### Proposed Revisions to a Standard Plans Index

Index Number: 649-010

Index Title: STEEL STRAIN POLE

FY 2023-24  
STANDARD PLANS

SHEET  
1 of 3

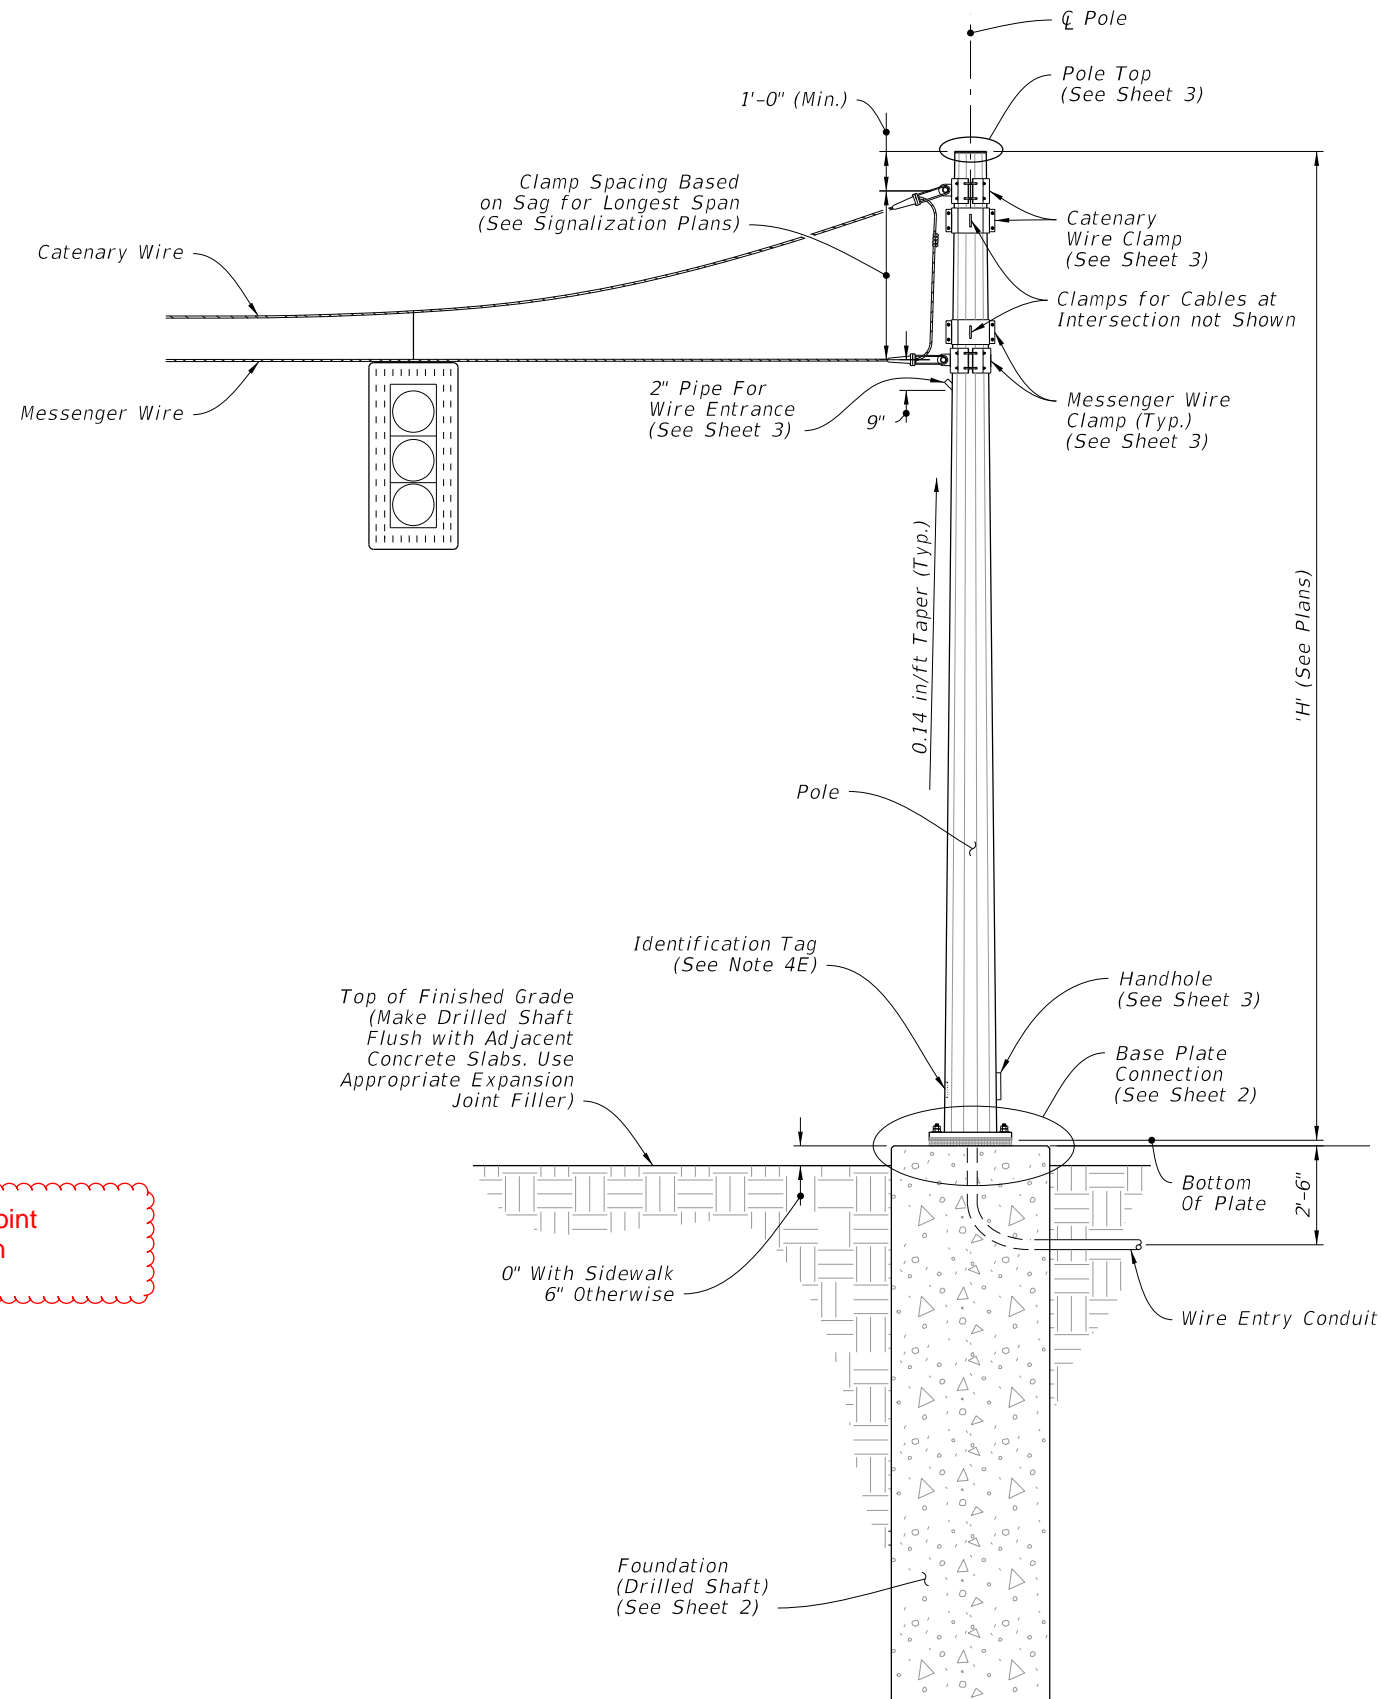
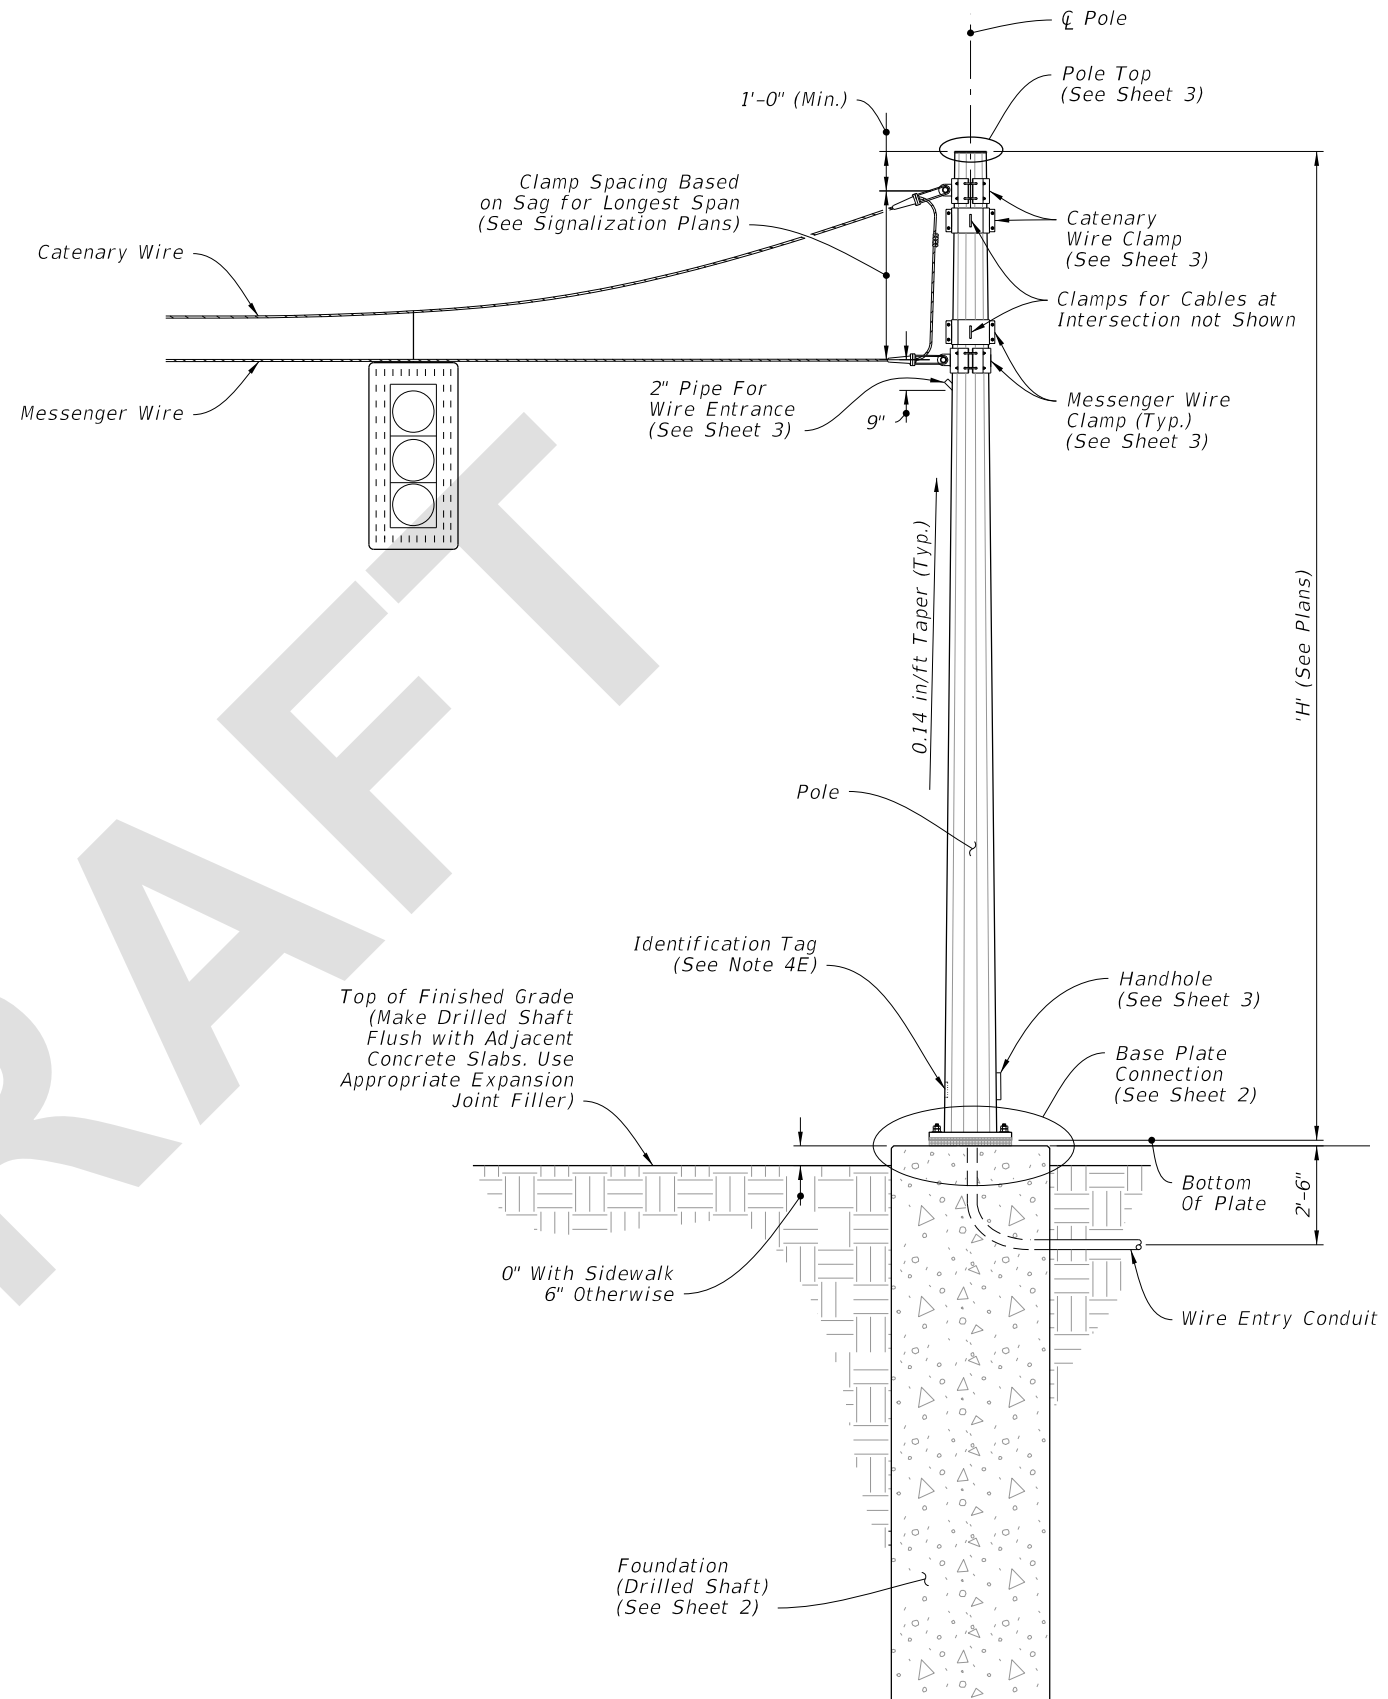
Sheet 1: Changed phrase from "full-penetration groove" to "complete joint penetration".

Sheet 1: Changing non-standard language to standard language consistent with AWS.

H. Fabricate longitudinal seam welds in pole with 60 percent minimum penetration or fusion welds except, within 6" of the base plate connection use full-penetration groove welds.

complete joint penetration

H. Fabricate longitudinal seam welds in pole with 60 percent minimum penetration or fusion welds except, within 6" of the base plate connection use complete joint penetration welds.

SHEET  
3 of 3

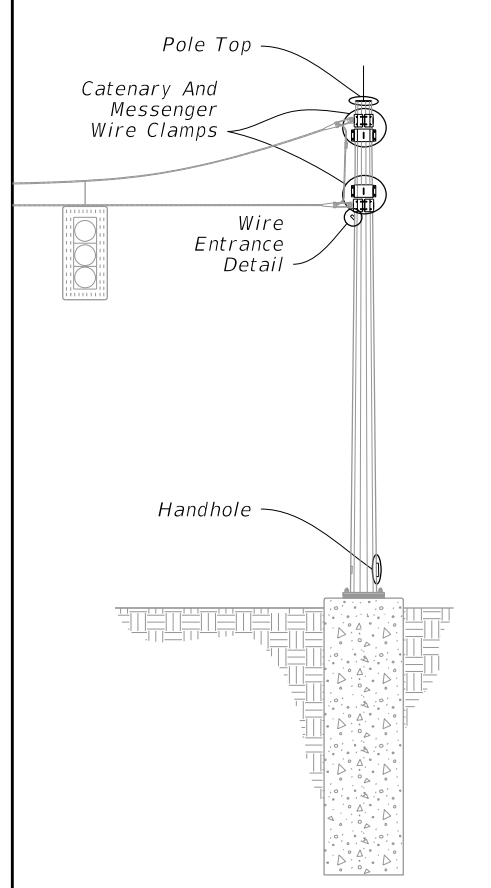
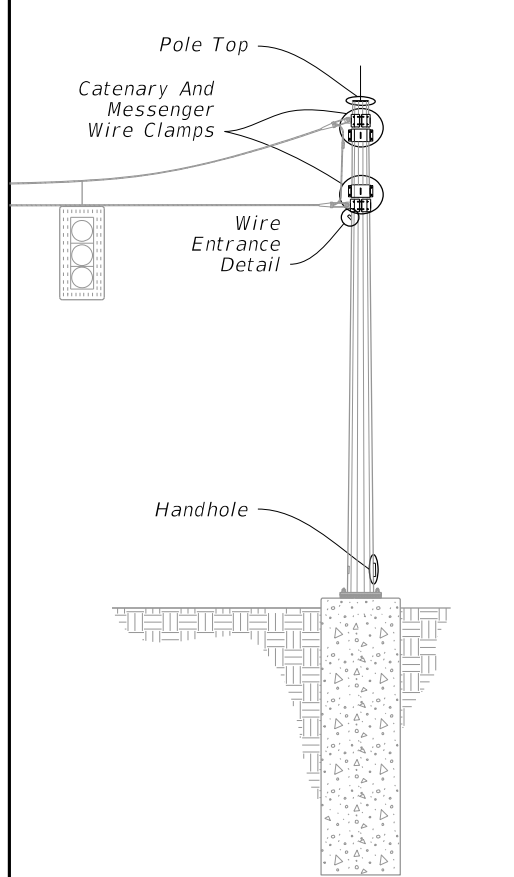
Sheet 3: Changed weld detail to say "CJP."

Sheet 3: Changing non-standard language to standard language consistent with AWS.
